# Work Order ID 108363

Item Name: Crosstube Turning Detail

<b>DART AEROSPACE LTD</b>	<b>Work Order:</b>	108363
<b>Description:</b> Crosstube Assembly (205/212/412 Low Fwd)	<b>Part Number:</b>	D212-664-147
<b>Inspection Dwg:</b> D212-664-147 <b>Rev:</b> B		Page 1 of 2

DRAWING NO. D212-664-147	TITLE CROSSTUBE ASS'Y (205 LOW FWD)	REV. B	<b>DART AEROSPACE LTD ENGINEERING ORDER</b>	D.E.O. NO. D212-664-147-B-1	SHEET NO. SHEET 1 OF 1	SCALE NTS
DRAWN <i>q</i>	CHECKED <i>ASS</i>	MFG. APPR. <i>18</i>	APPROVED <i>MP</i>	DE APPR. <i>14</i>		
DATE 11.07.15	DATE 11.07.20	DATE 11.07.21	DATE 11/07/21	DATE 11.07.21

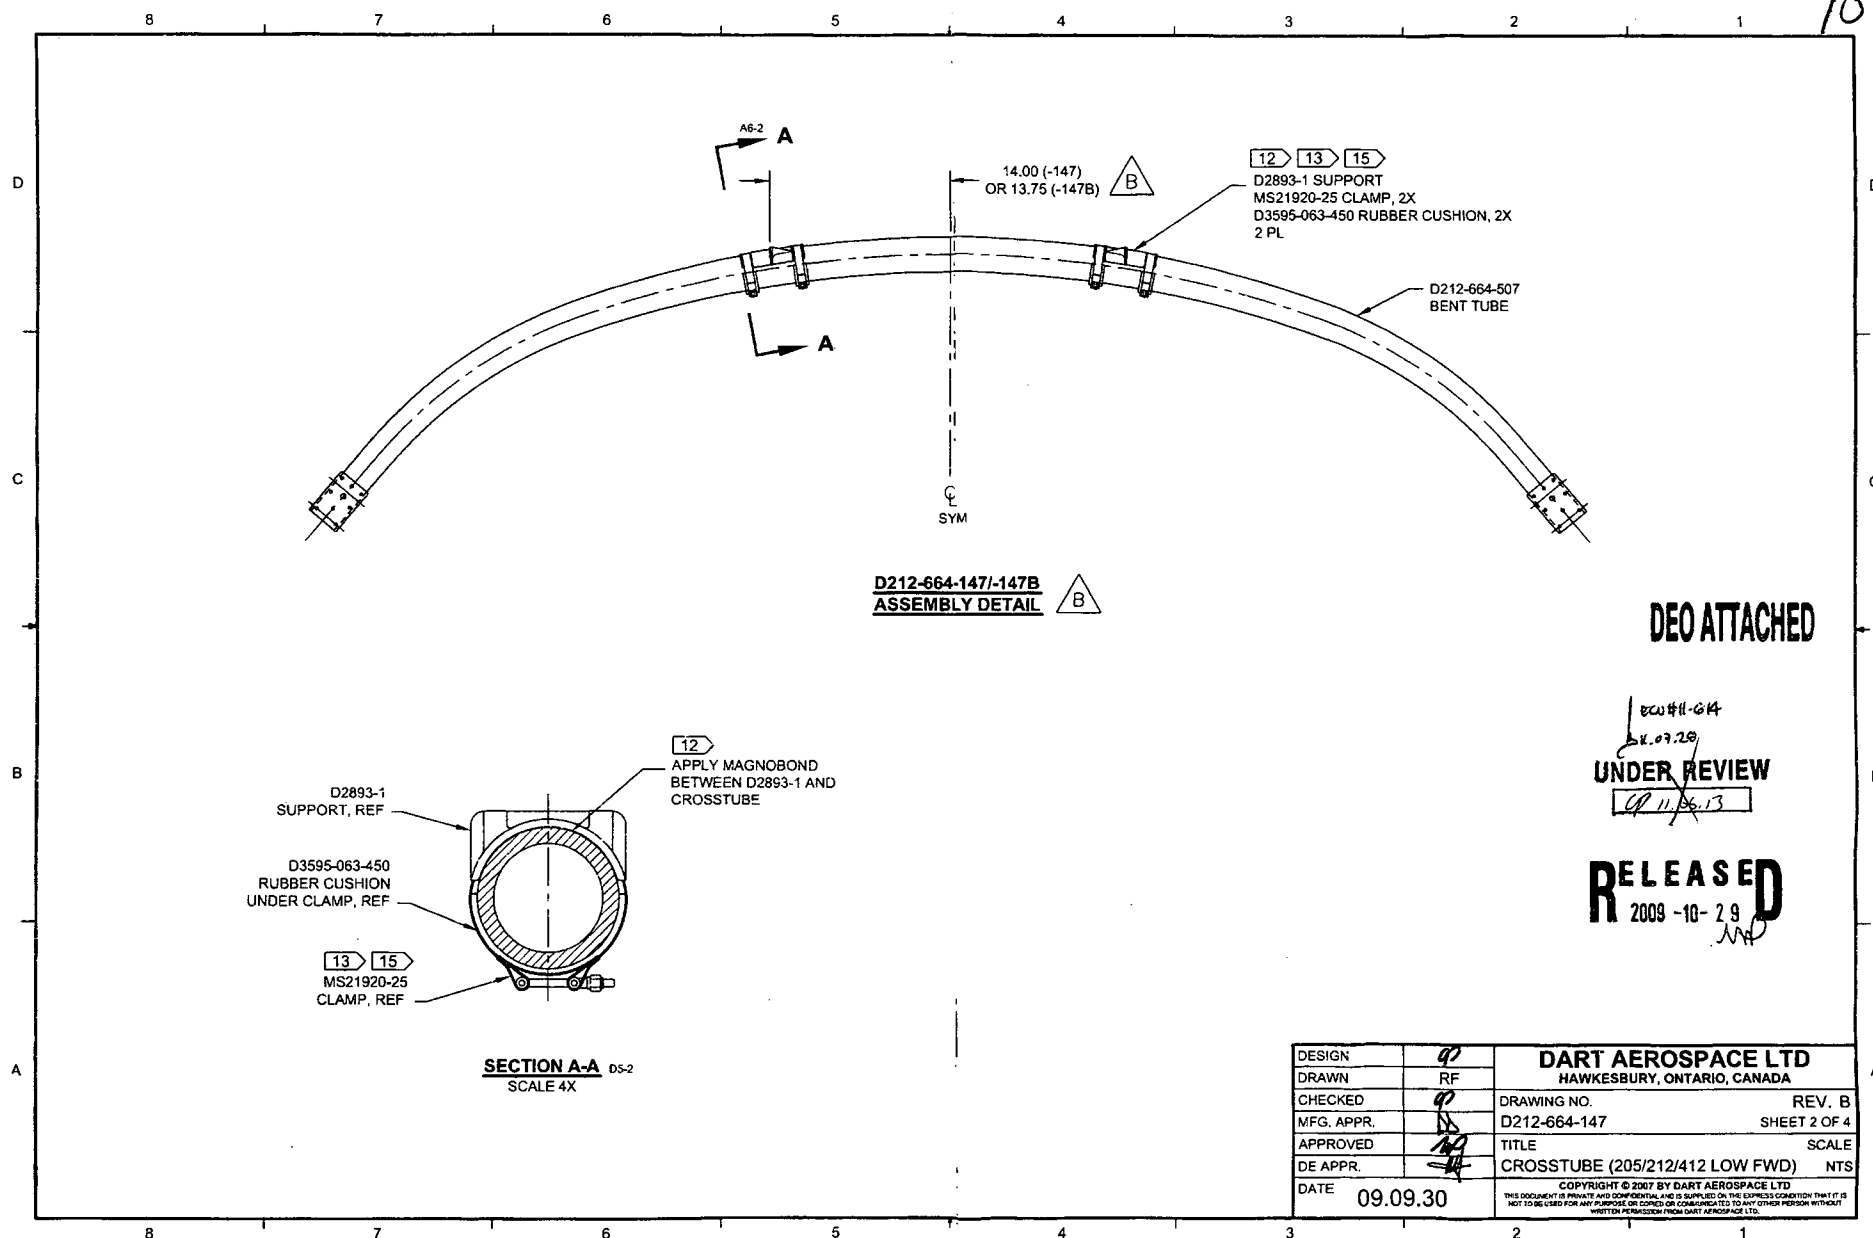
**PURPOSE:**

REPLACE MAGNOBOND WITH PROSEAL.

IS:

Item	Qty -147	Qty -147B	Part Number	Description
9	A/R	A/R	PROSEAL 890 B-2	SEALANT, AMS-S-8802 CLASS B-2

WAS:

9	A/R	A/R	MAGNOBOND 6398	ROCKWELL SPECIFICATION RBO-120-023 ADHESIVE (TEXTRON/BELL SPEC. 299-947-100, TYPE II, CLASS 2 ADHESIVE)
---	-----	-----	----------------	---

NOTE 12 & 15, SHEET 1 IS AMENDED AS FOLLOWS:

IS:

- 12) TO INSTALL D2893-1 SUPPORT: ABRASE MATING SURFACE OF SUPPORT AND CROSSTUBE WITH 180-GRIT SANDPAPER AND REMOVE RESIDUE WITH MEK (OR EQUIVALENT). APPLY A 0.04" TO 0.07" THICK LAYER OF PROSEAL 890 CLASS B-2 (OR AMS-S-8802 CLASS B-2) SEALANT TO MATING SURFACE OF SUPPORT.
- 15) TORQUE CLAMPS 80 TO 100 IN-LB. ENSURE AT LEAST 1.5 THREADS SHOWING IN SAFETY AND THAT NUT HAS NOT BOTTOMED-OUT AFTER TORQUING. **PRIOR TO PACKAGING, RE-CHECK TORQUE ON CLAMPS AFTER PROSEAL 890 SEALANT HAS CURED FOR 72 HOURS.**

WAS:

- 12) INSTALL D2893-1 SUPPORT USING 0.03" TO 0.06" THICK LAYER OF MAGNOBOND 6398 TO THE SURFACE OF D2893-1 THAT WILL BE IN CONTACT WITH THE CROSSTUBE PER QSI 015. LET CURE FOR 12 HOURS AFTER INSTALLATION AND PRIOR TO PACKAGING.
- 15) TORQUE CLAMPS 80 TO 100 IN-LB. ENSURE AT LEAST 1.5 THREADS SHOWING IN SAFETY AND THAT NUT HAS NOT BOTTOMED-OUT AFTER TORQUING.
